Interactive comment on “ML-SWAN-v1: a hybrid machine learning framework for the prediction of daily surface water nutrient concentrations” by Benya Wang et al.

Benya Wang et al.

Received and published: 6 June 2020

Fig. 1. correlation_between_nutrients

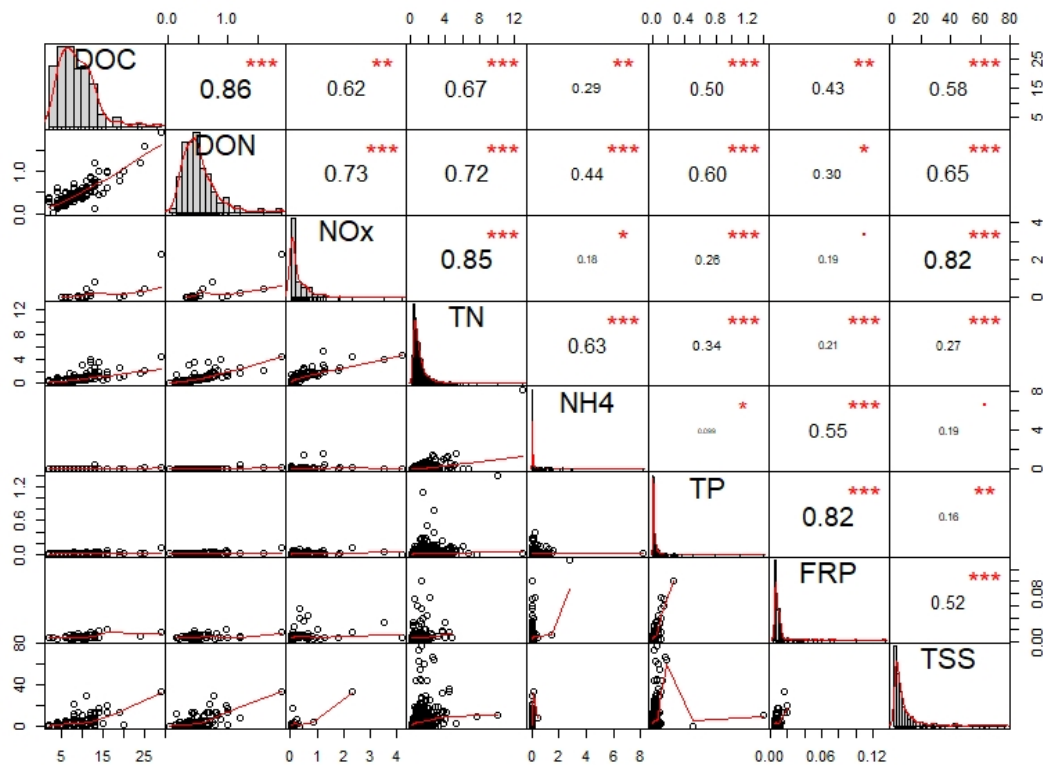
Two additions are recommended related to this observation: 1. Presentation of the relationships between in the inputs and outputs would be informative. As noted in the discussion (line 445) correlation tests can be used to assess the which parameters would be useful for pre-generation. Potentially a scatter plot matrix, with correlation values on the lower diagonal, would be useful to show the relationships concisely.

Response: Thanks for your comments. Please find the attached figure. We did this analysis before the modelling phase. There are strong relationships between nutrients. This is also one of the assumptions for this hybrid model that if we can pre-generate

these nutrients and they can be further used in the final model to predict final target nutrient. In that case, the model could have higher accuracy. We will update the manuscript to include this figure in the result section or in the supplement.
